Service Bulletin

NO:PV2-01-016

SUBJECT: MDX-M2000 Change LS Cam Plate Adjustment

MODEL (S): MDX-M2000

4-9. LS Cam Plate Position Adjustment

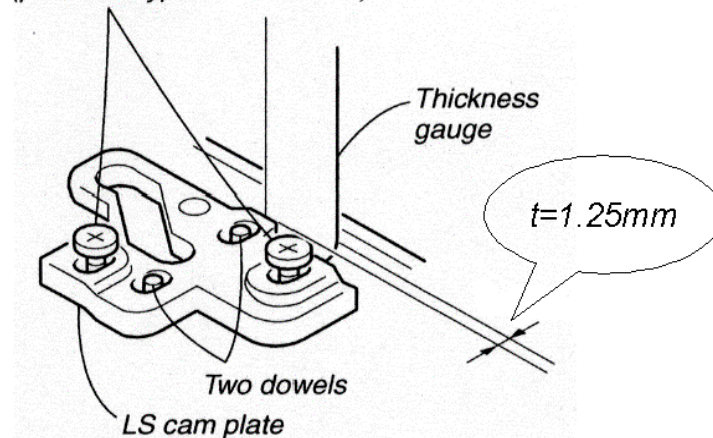
Symptom: When a tape UL, it can be malfunction for UL operation that caused by guide base (T) assy. Then, we have change in LS cam plate position adjustment.

Please make correction as follow:

- 2)slide LS chassis block assy 1. to opposite of drum so as to remove play.
- 3)the thickness gauge (Ref. No.J-16)
correct $t=0.6\text{mm}$ to $t=1.25\text{mm}$, as follows.
